ITEM No. 4.

**RECTIFICATION OF WATER LEAKS ON MOULDINGS**

ITEM No. 5.

**INTERCHANGEABILITY OF EXHAUST SYSTEM COMPONENTS**

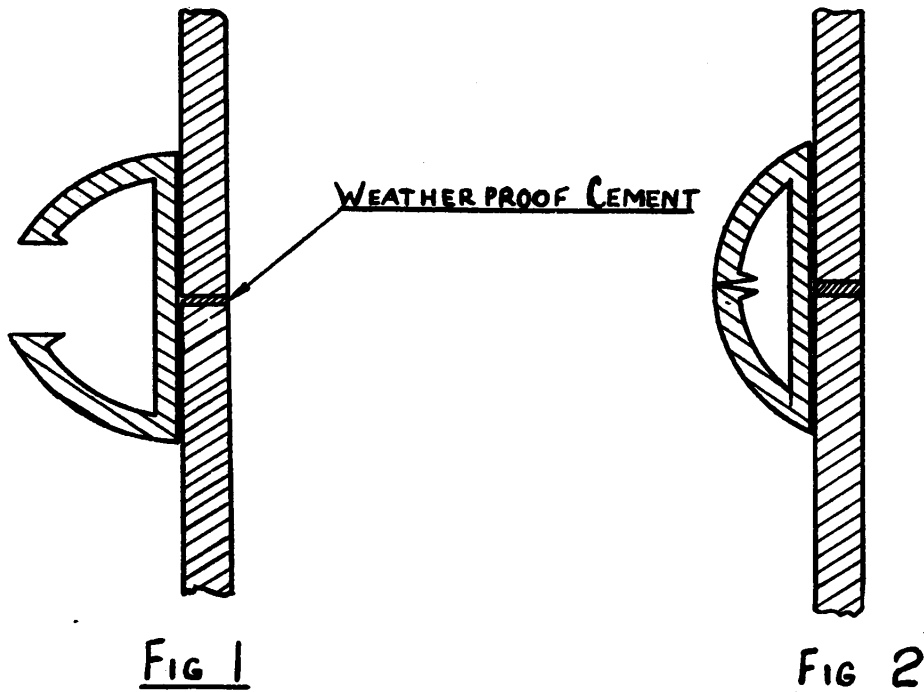
Leakage into the body may occur through faulty panel joints. These are weather proofed with a sealing cement and covered with closed down mouldings, fixed in position with serrated nails.

To eliminate this trouble remove the moulding from the body panel and apply Bostik or any other good weather-proofing cement evenly between the panels.

Whilst the jointing is still "tacky" an entirely new moulding must be affixed and closed down in position. See Fig. 2.
